ADDENDUM NO. 2

PROJECT NAME: Textile Design Studio Renovation
UNL PROJECT NUMBER: A075P003
INVITATION NO.: 2050-12-7200

DATE OF ISSUANCE: January 23, 2013

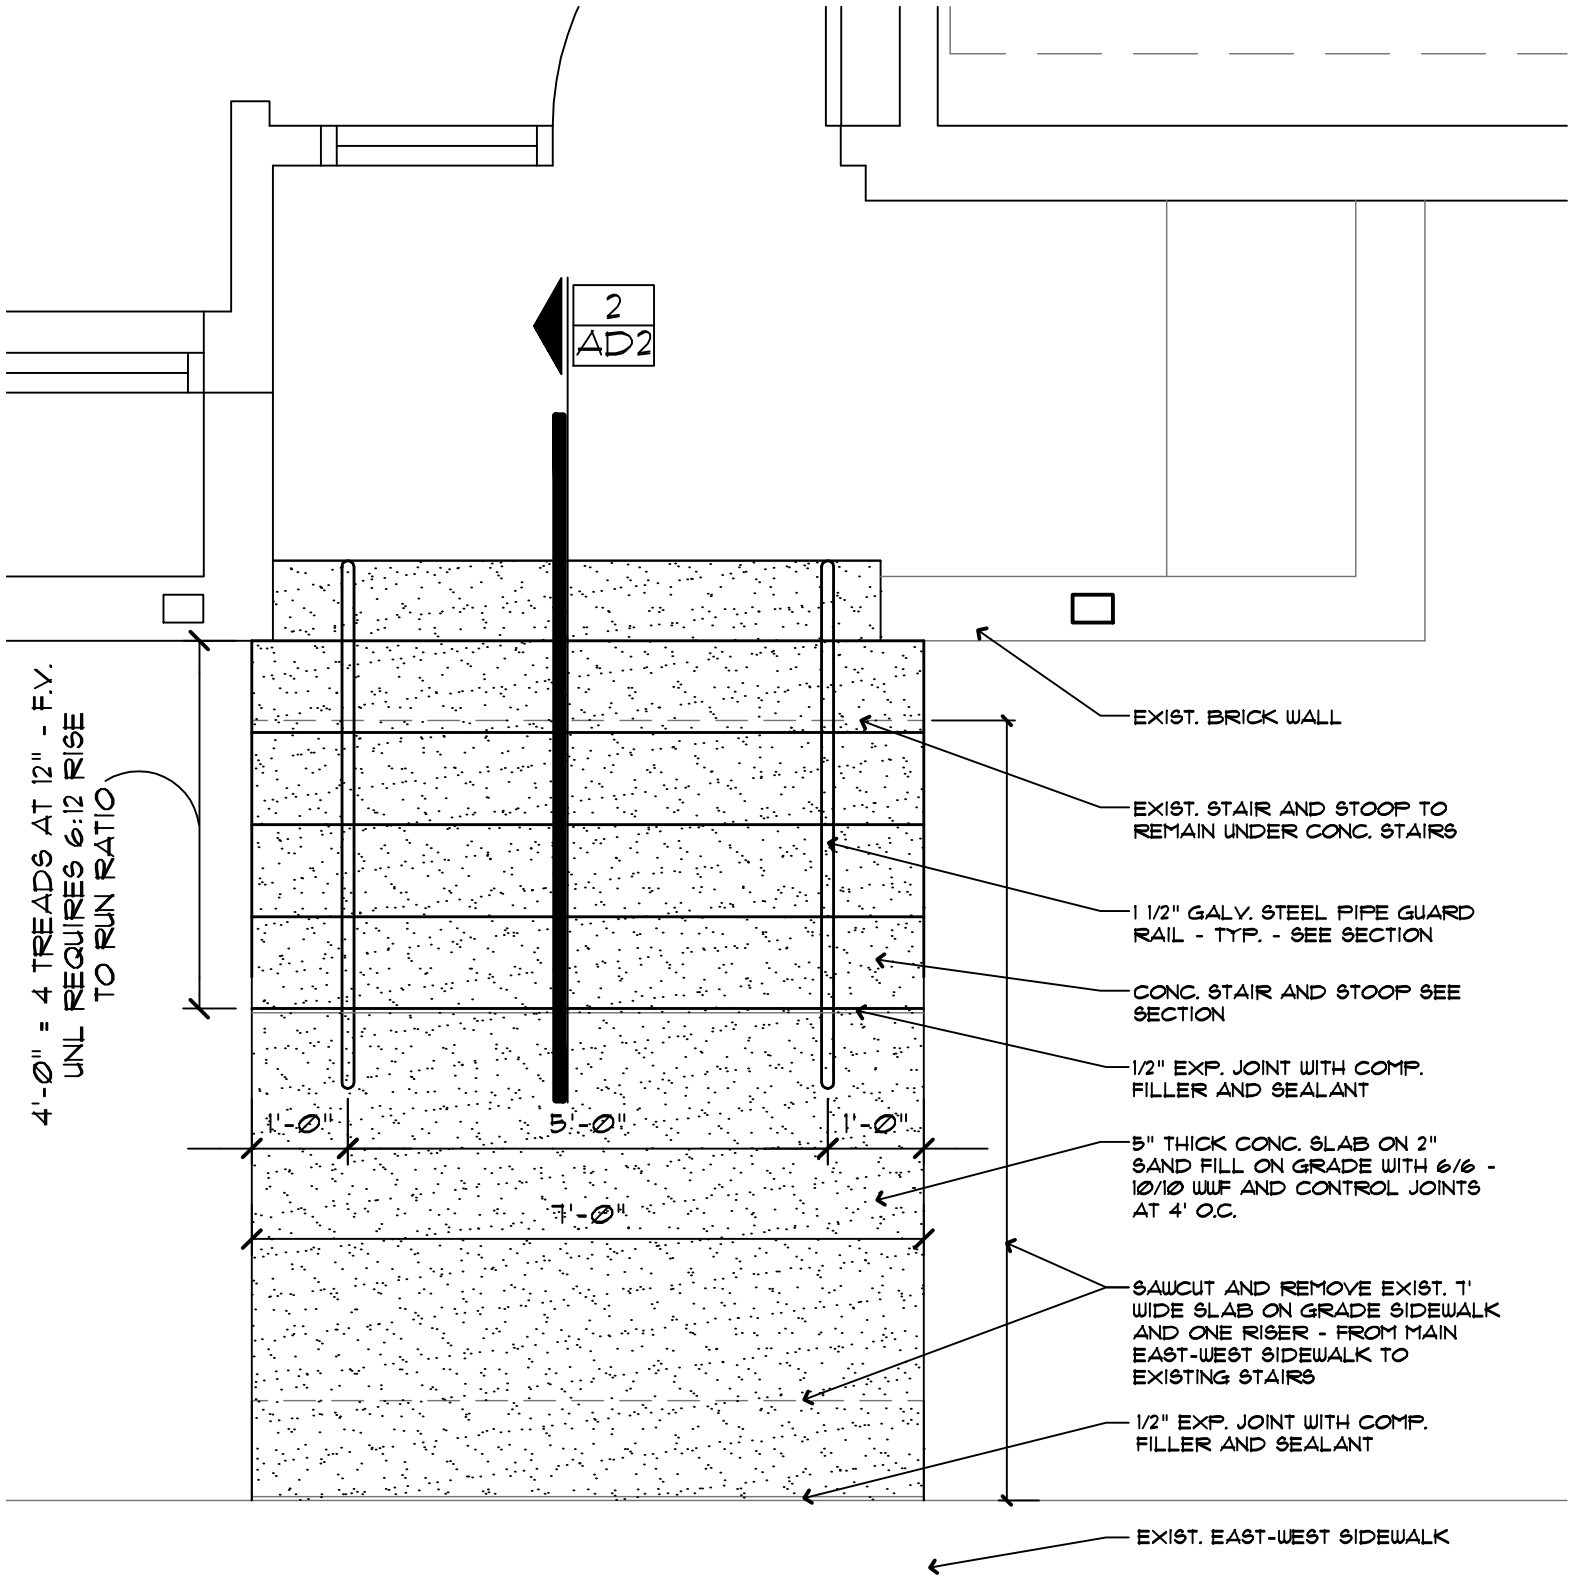
- b. At the Basement Mech. Room 01, add 5/8" type 'X' gyp board at the bottom of the wood floor joists under Toilet 104 and under the portion of Custodial Closet 110 that occurs over Mechanical Room 01, for a 1-hour fire rated floor-ceiling assembly. Attach the gyp board to the wood joists with 5d cooler or gyp board nails at 6 inches on center. Include miscellaneous wood blocking as needed. End joints of gyp board are to be centered on joists. Fire tape the gyp board joints and fire caulk penetrations in gyp board. Also, turn this 5/8" gyp vertically up to the wood subfloor under the north and east walls of Toilet 104 and under the west wall of Custodial Closet 110. Attach the vertical gyp board onto 2x wood blocking as noted above. See attached plan detail No. 3 showing the partial plan of Basement Level from sheet A1-1 and see attached detail No. 6.

- e. At the south wall of Basement Mech. Room 01, remove the existing wood framing around the existing crawl space access masonry opening. Sawcut and remove the 2 CMU immediately below the opening. Add a 45-minute or 1-hour fire rated wall access door at the opening. Fire rated access door to be Nystrom type UT, factory primed (no field paint). Existing masonry opening will be approximately 32" tall by 32" wide. Field verify exact door size required to avoid existing plumbing pipes while maximizing door size. Include framing and drywall above door as needed to fill existing opening. Install treated 1x to

cover top of CMU at access door sill. See attached plan detail No. 3 showing the partial plan of Basement Level from sheet A1-1

ENLARGED PARTIAL STAIR SITE PLAN

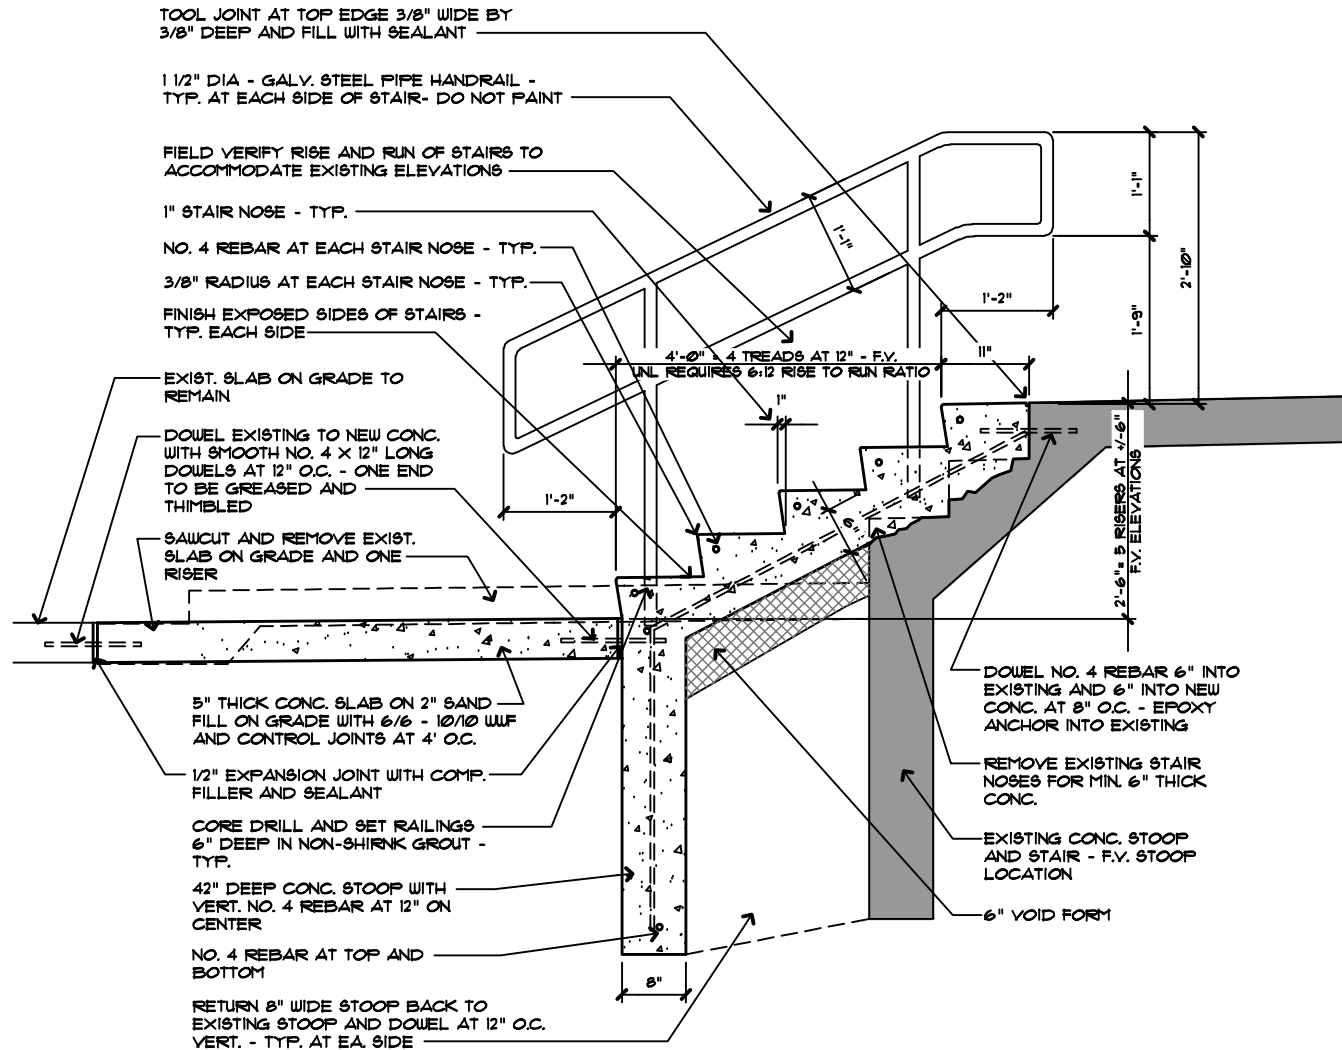
1. Sawcut and remove existing north-south slab on grade sidewalk and single riser from existing stairs to existing east-west sidewalk. Add 7' wide x 5" thick concrete slab on grade sidewalk from existing east-west sidewalk to new stairs. Include 1/2" expansion joints with compressible filler and sealant and dowels at each end of sidewalk. Slope sidewalk to south at 1:21 slope to drain. See attached, enlarged partial site stair plan of entry stairs - detail No. 1. Field verify extent of sidewalk.

2. Install concrete stoop and concrete stairs at existing stair location - as shown on attached stair section - detail No. 2
3. Revise grading to 2" below new sidewalk elevation per UNL standards at each side of new sidewalk to accommodate new lower sidewalk elevation. Extend grading work and feather-out cut in grade 5' east and 5' west of existing sidewalk. UNL to provide seeding work.
4. Include handrails at each side of stairs as shown on attached stair section detail No. 2 and stair plan detail No. 1.

2 STAIR SECTION & RAILING DETAIL

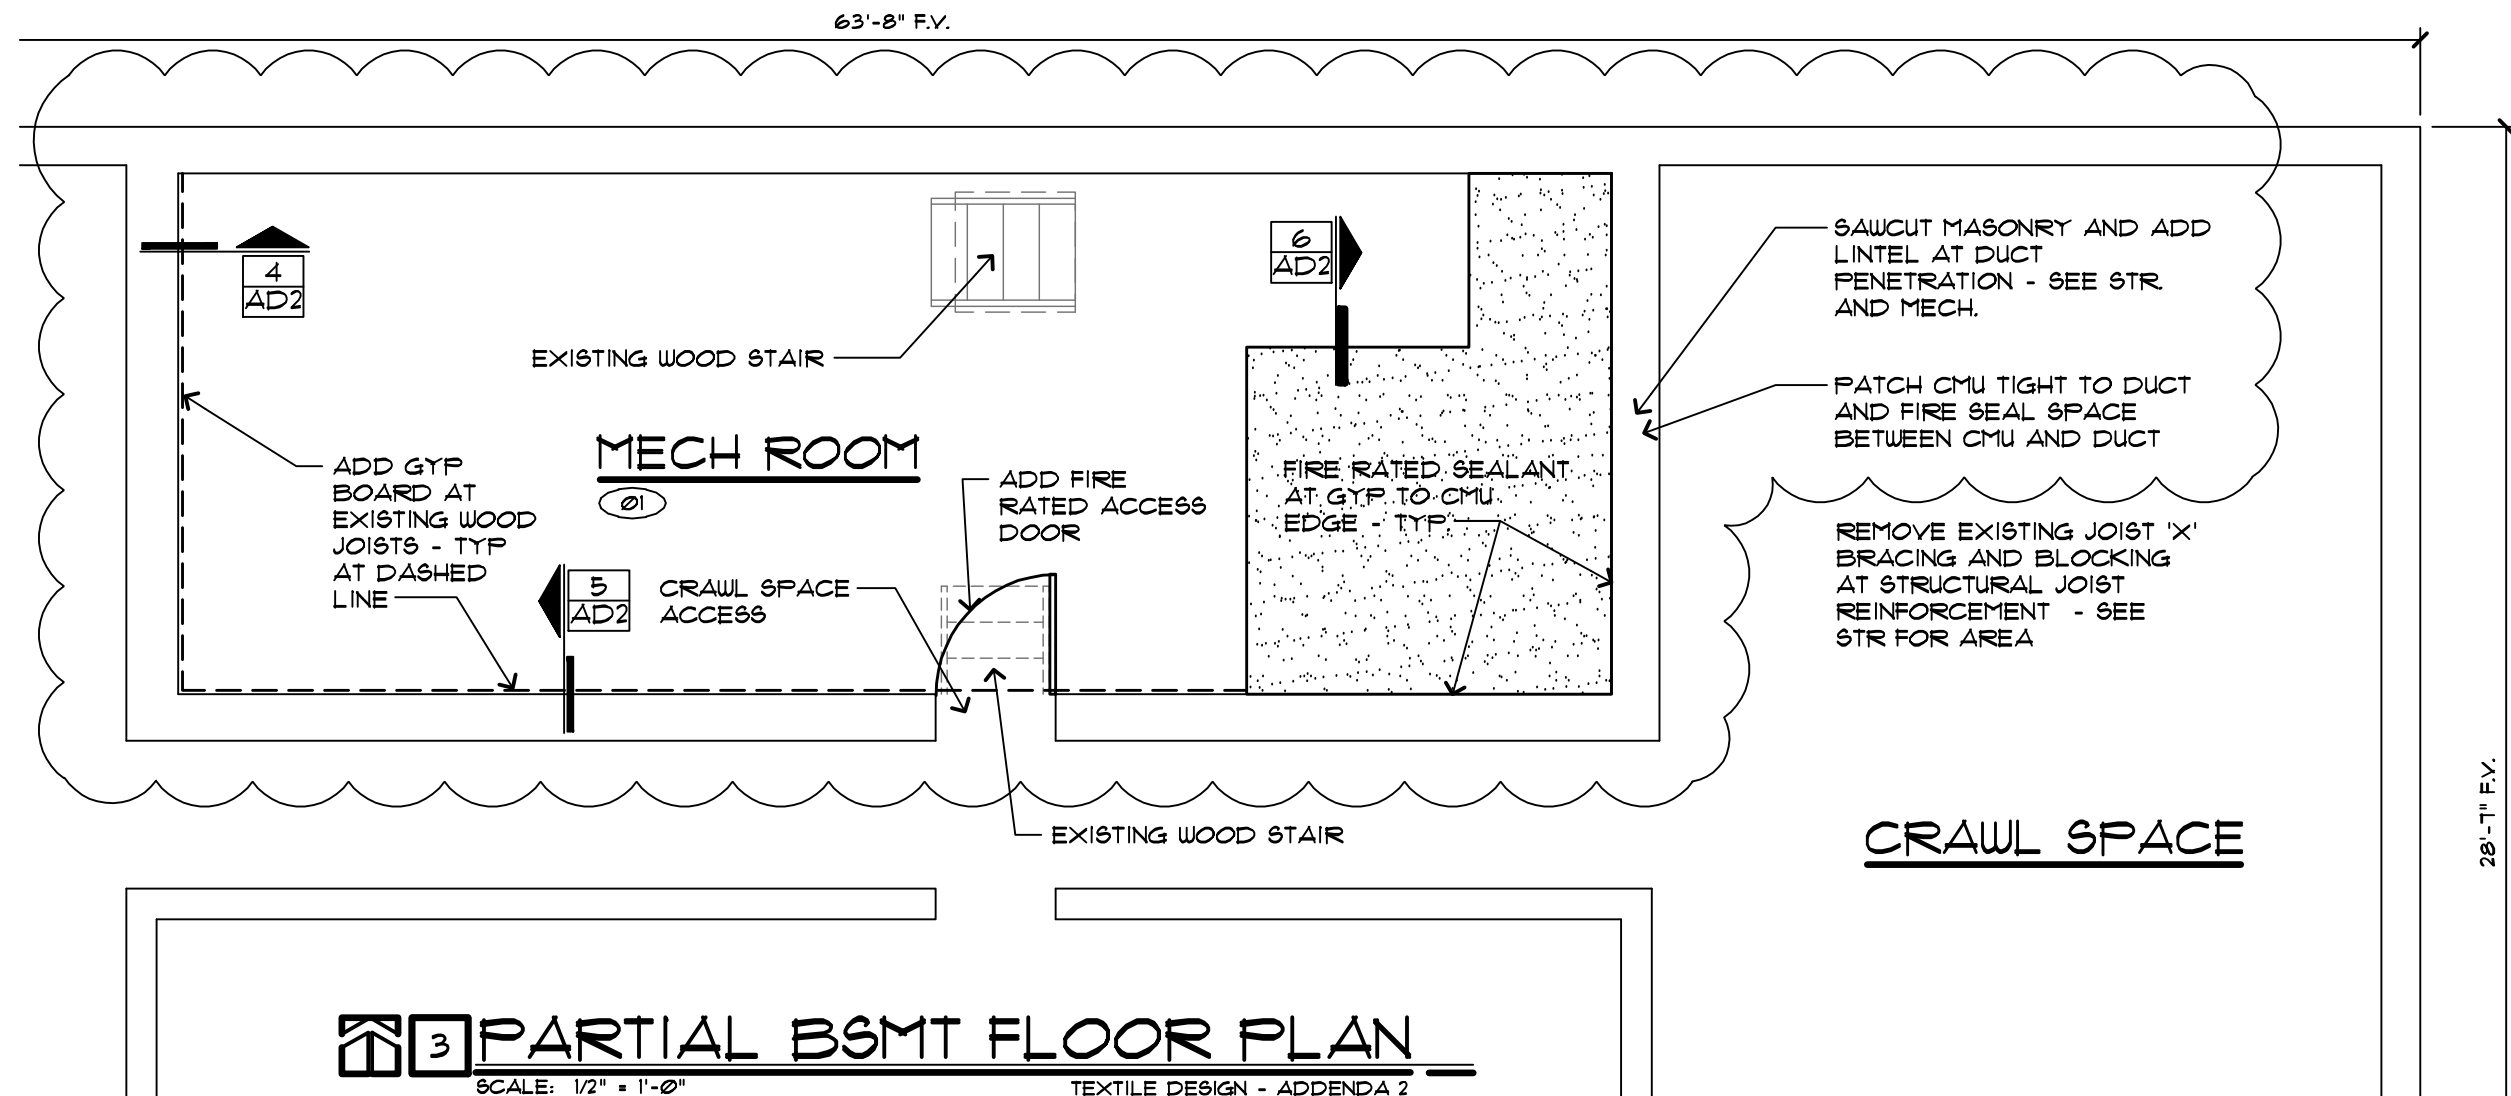
1. Delete detail 3 'Handrail Elevation Detail' and see attached detail No. 2 for revised handrail detail. Provide one handrail at each side of stairs.

4 GYP INFILL - WEST WALL
SCALE: 1" = 1'-0" TEXTILE DESIGN - ADDENDA 2

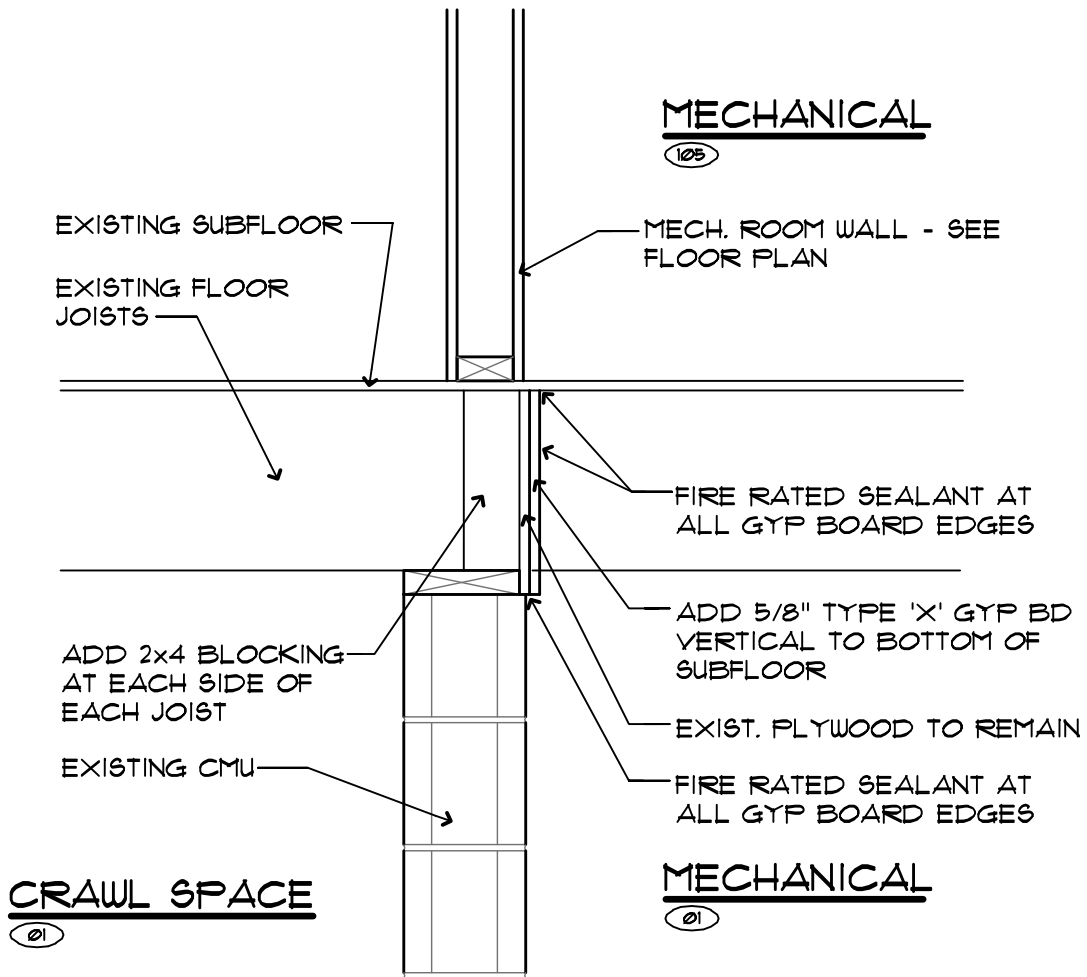
- c. At the West and South walls of the Basement Mech. Room 01, at the joist space between the top of the CMU bearing wall and the bottom of the wood subfloor, add 5/8" type 'X' gyp board on 2x4 wood blocking. At the west wall, gyp board is to cover the rim joist per the attached detail 4. At the south wall, gyp board is to infill the area between joists per the attached detail No. 5. Install fire rated sealant at all gyp board edges.
